NUCLEAR REACTOR LABORATORY
AN INTERDEPARTMENTAL CENTER OF
MASSACHUSETTS INSTITUTE OF TECHNOLOGY

Subject: License Amendment for MIT Research Reactor, License No. R-37, Docket No. 50-20, Technical Specification No. 6.6 - "Design and Operation of the Fission Converter Facility"

Safety Review #-0-01-8 – Changes to MITR Technical Specification 6.6.3

Model 709 Level Switch Float and Body Top-Mounted, One Switch Station

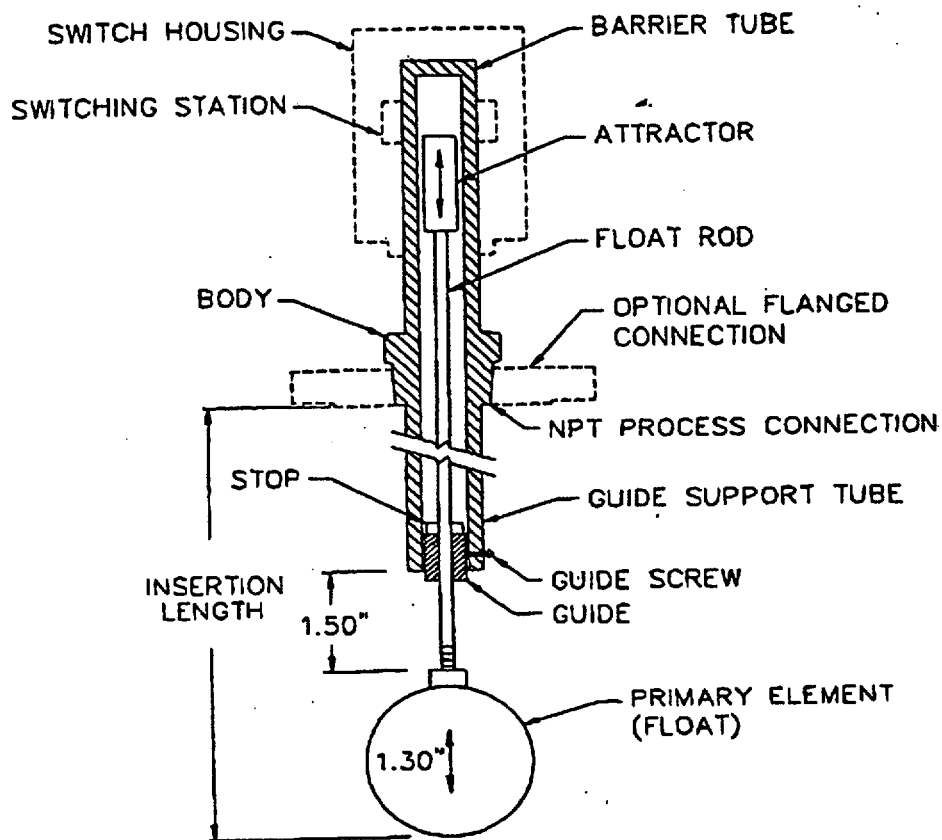
Specification 2(d) The Fission Converter (FC) tank coolant level channel provides a reactor scram and CCS closure if the FC coolant drops below 2.1 m above the top of the fuel. The level probe (a float switch, vendor's diagram attached) is set to activate at 2.2 m above the top of the fuel. This position is not adjustable. Any significant positioning changes would occur only if the switch were to become detached from its position. If this were the case, the level probe functional test as required in TS 6.6.3.1 would indicate the malfunction.

A calibration, as required in TS 6.6.3.2, is very difficult in that the FC top shielding and lid cover must be removed, D₂O slowly removed from the FC tank, and the level measured. This requires significant manpower and personnel dose to measure an activation level which cannot change. It is therefore proposed to eliminate TS 6.6.3.2(d). It should be noted that TS 6.6.3.1 remains unchanged and it requires, among other things, an operability check of the FC tank coolant level channel. Hence, the proposed elimination of TS 6.6.3.2(d) does not decrease safety. Operability of the level channel is still assured via testing. The only change is to eliminate a calibration requirement that is both difficult to perform and wasteful of D₂O, and which provides no benefit because the probe's position isn't subject to gradual change. The only possible failures in design are abrupt and those are detected by the functional test.

Calculated pH - Conductivity Relationship for Water + "Typical" Acid or Base

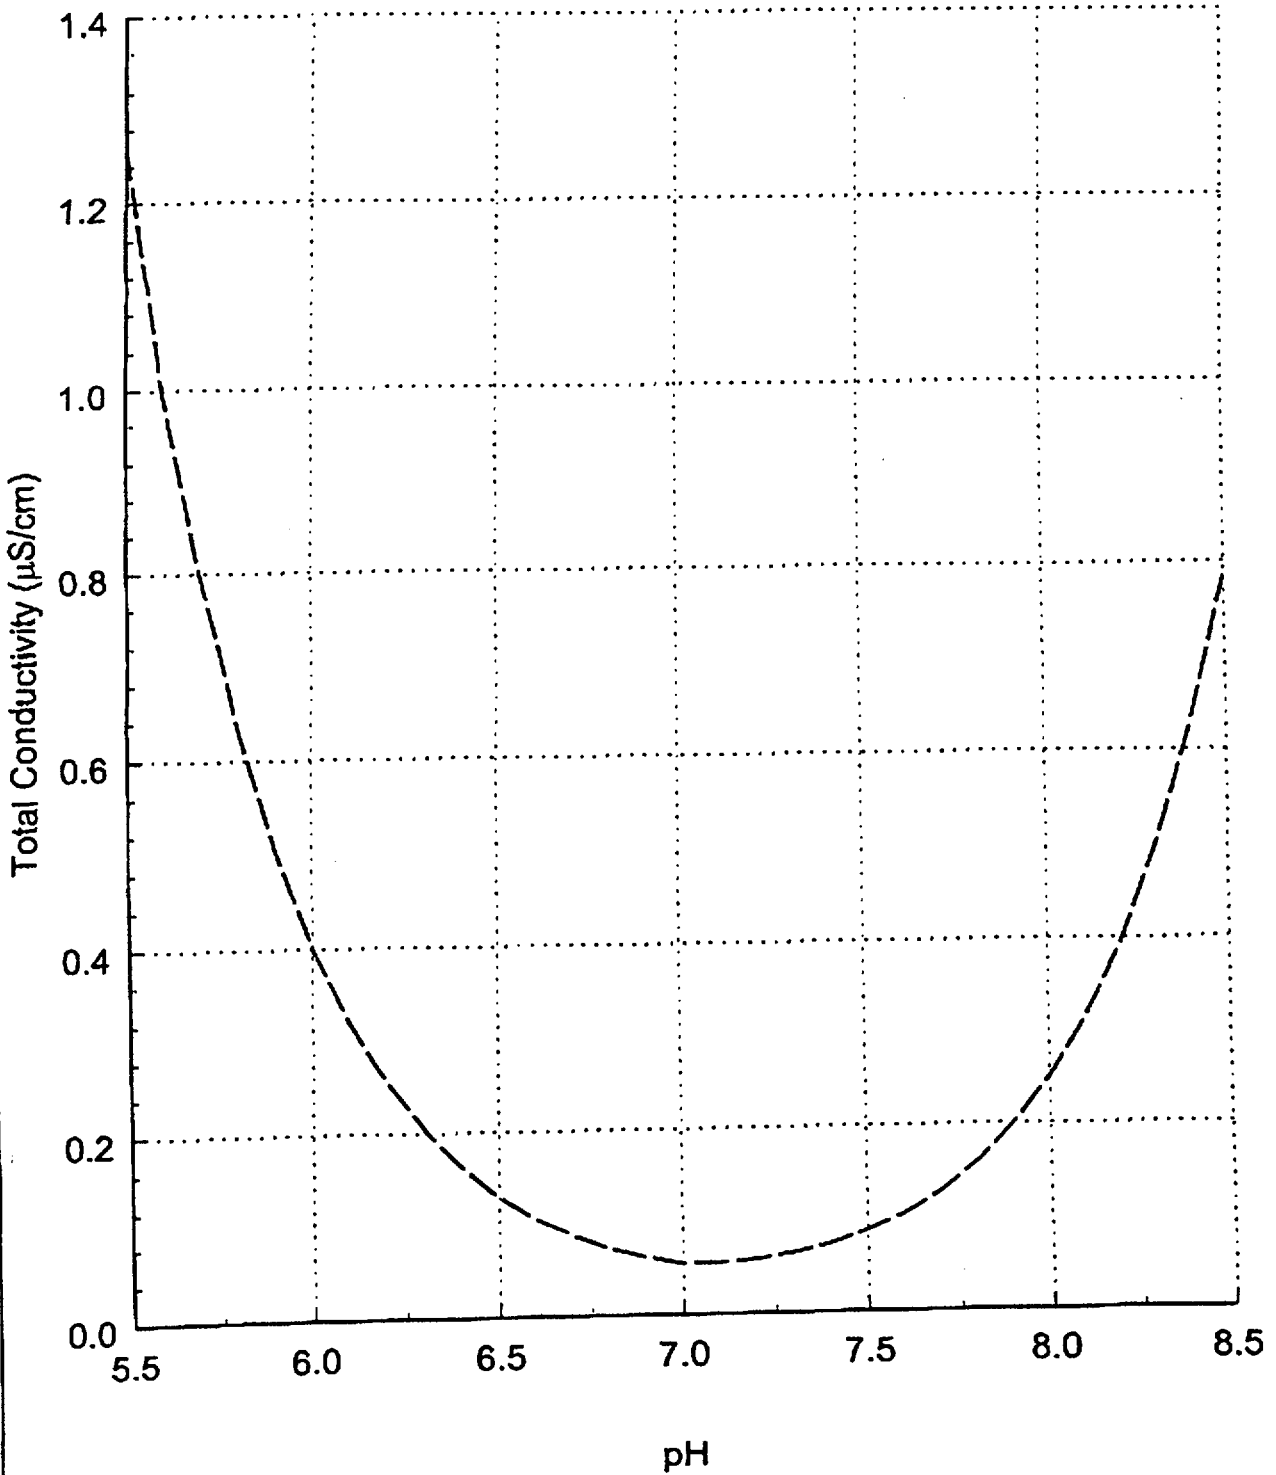
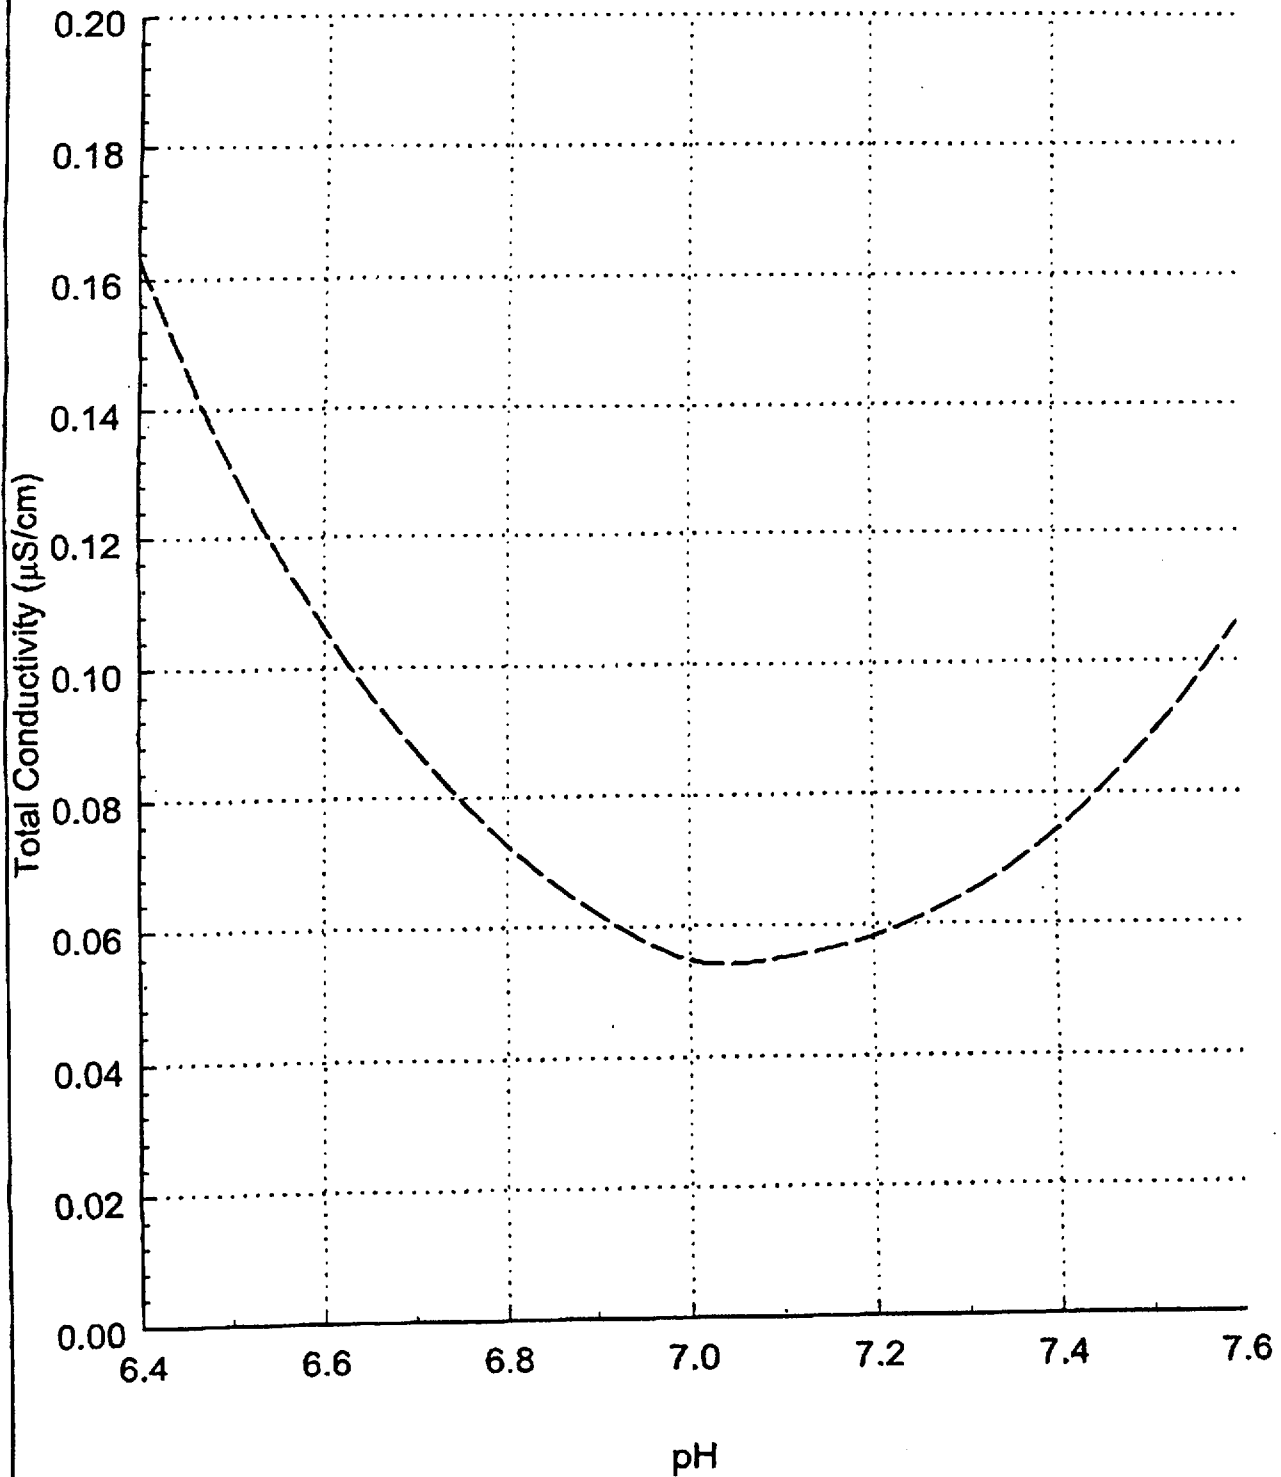
Specification 4 Since the FC coolant is high purity D₂O, and is continually circulated through a cleanup loop, the ionic strength of the D₂O is very weak, making pH measurements difficult. In addition, pH measurements result in above 10 ml of D₂O being wasted each month. A low conductivity would also mean that the pH must be near 7.0 (see attached memo from G. Kohse). Typical FC conductivity readings are about 0.06 μ S/cm. These readings are taken prior to FC operation, with the temperature never exceeding 35 °C. It is proposed to change the wording of T.S. 6.6.3 as follows:

The attached figures plot the conductivity – pH relationship obtained by this procedure, first for the pH range 5.5 – 8.5 and then an expansion of the region from pH 6.4-7.6. To use the figures to establish a probable pH range for any given conductivity, simply draw a horizontal line at the conductivity value and note the x-intercepts of this line on the curve. If ionic species are present which do not affect the pH, the actual pH range would be represented by a lower conductivity value and hence would be closer to neutral. For example, if the conductivity is measured to be $0.06 \mu S/cm$, the pH must lie between about 6.9 and 7.2. It is therefore unnecessary to do a batch pH measurement to confirm that pH is within the allowable limits, particularly if no change in conductivity has been observed since the most recent pH measurement.

4. The gross β - γ activity of the fission converter primary coolant shall be determined at least monthly. The conductivity of the fission converter primary coolant shall be determined either by a continuous on-line instrument or a monthly sample.

The pH of the fission converter primary coolant shall be measured monthly if the average conductivity exceeds 0.10 $\mu\text{S}/\text{cm}$. The tritium content of the coolant shall be determined quarterly if D_2O is used as the fission converter primary coolant.
